SUNDRY NOTICES AND REPORTS ON WELLS (DO NOT USE THIS FORM FOR PROPOSALS TO DRILL OR TO DEEPEN OR PLUG BACK TO A DIFFERENT RESERVOIR. USE "APPLICATION FOR PERMIT" (FORM C-101) FOR SUCH PROPOSALS.) 1. Type of Well: Oil Well <input checked="" type="checkbox"/> Gas Well <input type="checkbox"/> Other <input type="checkbox"/>		WELL API NO. 30-005-20035 5. Indicate Type of Lease STATE <input checked="" type="checkbox"/> FEE <input type="checkbox"/> 6. State Oil & Gas Lease No.

2. Name of Operator Cano Petro of New Mexico, Inc.		7. Lease Name or Unit Agreement Name Cato San Andres Unit
3. Address of Operator 801 Cherry Street Suite 3200 Unit 25 Fort Worth, TX 76102		8. Well Number 124

Wellbore Diagram

Plug And Abandonment Procedure

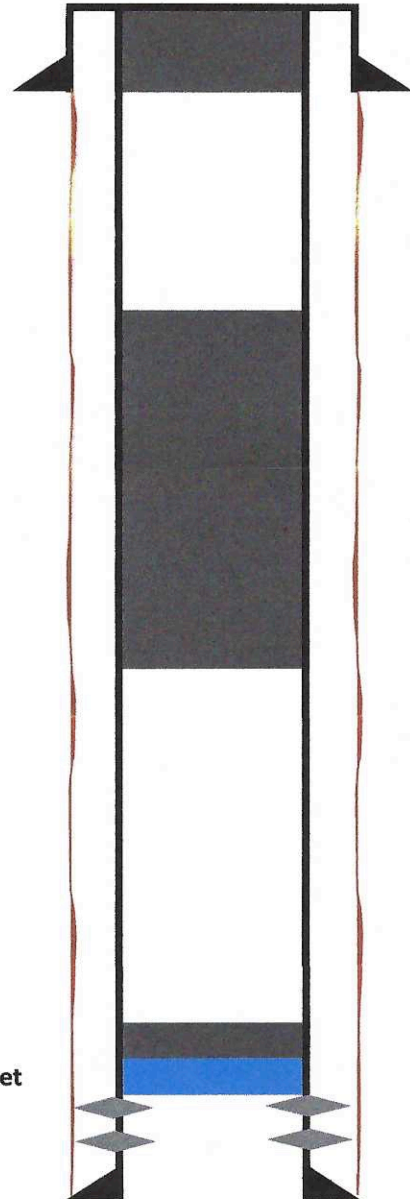
C

25 6 sacks of Class G Cement

C

11. Plug 1 (San Andres Perforations and Formation Top 3233'-3183', ²⁵6 ^CSacks Class G Cement)
Mix ²⁵6 ^C sx Class G cement and spot a balanced plug inside casing to cover the San Andres perforations and formation top.

12. Plug 2 (Yates and Rustler Formation Tops 1595'-972', 50 Sacks Class G ^C Cement)
Mix 50 sx Class ^C G cement and spot a balanced plug inside casing to cover the Yates and Rustler formation tops.

13. Plug 3 (Surface Casing Shoe 502'-Surface, 40 Sacks Class ^CG Cement)
Attempt to pressure test the bradenhead annulus to 300 psi; note the volume to load. If BH annulus holds pressure, then establish circulation out casing valve with water. Mix approximately 40 sx cement and spot a balanced plug from 502' to surface, circulate good cement out of casing valve. TOH and LD tubing. Shut well in and WOC. If BH annulus does not test, then perforate at the appropriate depth and attempt to circulate cement to surface filling the casing from 502' and the annulus from the squeeze holes to surface. Shut in well and WOC.

Operator: J.A. DRAKE WELL SERVICE INC. 607 W Pinon Farmington, NM87401			OGRID: 330485	Action Number: 15895	Action Type: C-103F
OCD Reviewer	Condition				
kfortner	See Attached Conditions of Approval Note Changes to Procedure
